Please find below the response to the review formulated for the CDM project “Tangshan Jidong Cement Fengrun District 12MW Cement Waste heat Recovery Project “ with the registration number 2733. In case you have any further inquiries please let us know as we kindly assist you.

Response to the CDM Executive Board

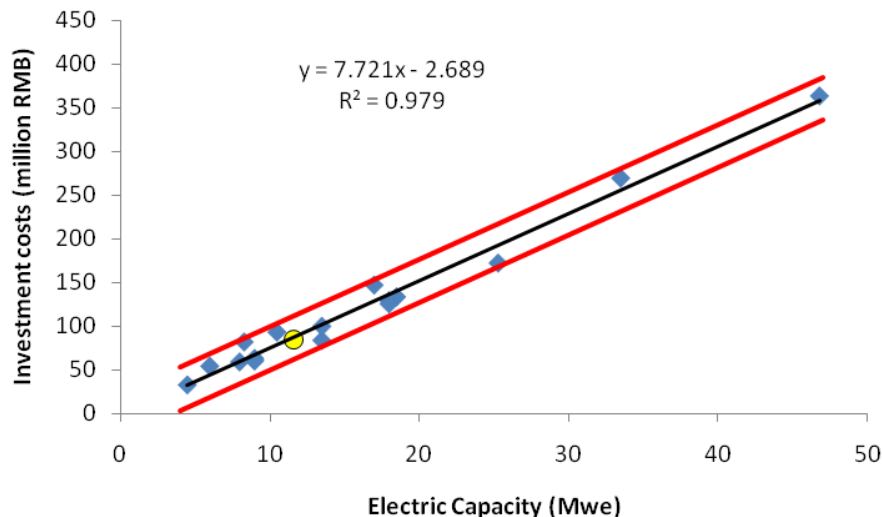
Further clarification is required on how the DOE has validated the suitability of the input values to the investment analysis in particular, the investment costs as per EB 38, para 54(c).

2. Further clarification is required on how the DOE has validated the suitability of the input values to the investment analysis in particular, the investment costs as per EB 38, para 54(c).

Additional to above, we have compared the investment cost of the proposed project in the FSR (i.e. 84,788,100 RMB) to similar registered projects listed in Annex 1. The projects are plotted in a scatter graph with their Investment costs in million RMB on the (y)-axis and the installed electric capacity in MWe on the (x)-axis. These projects are the basis of the regression analysis. The investment costs were predicted based on the average mean of the Investment cost per total installed capacity and the standard deviation. The regression formula has been defined as:

$$\text{Inv (million RMB)} = 7.721 \text{ Cap (MWe)} - 2.689$$

The correlation coefficient of R^2 of 0.979 indicates a high correlation between the capacity and investment costs. The standard error of 12.49 has been calculated based on the difference between the predicted (theoretical) values and the investment costs listed in the PDDs.

The figure below depicts a regression analysis assuming a linear relationship between the investment costs in RMB and installed capacity in MW for similar cement WHR projects. The proposed project activity (yellow dot) is well within 2 standard errors (indicated in red line) from

the black trend line, which means that the estimated Investment cost of the project activity is similar to the investment cost of similar projects.
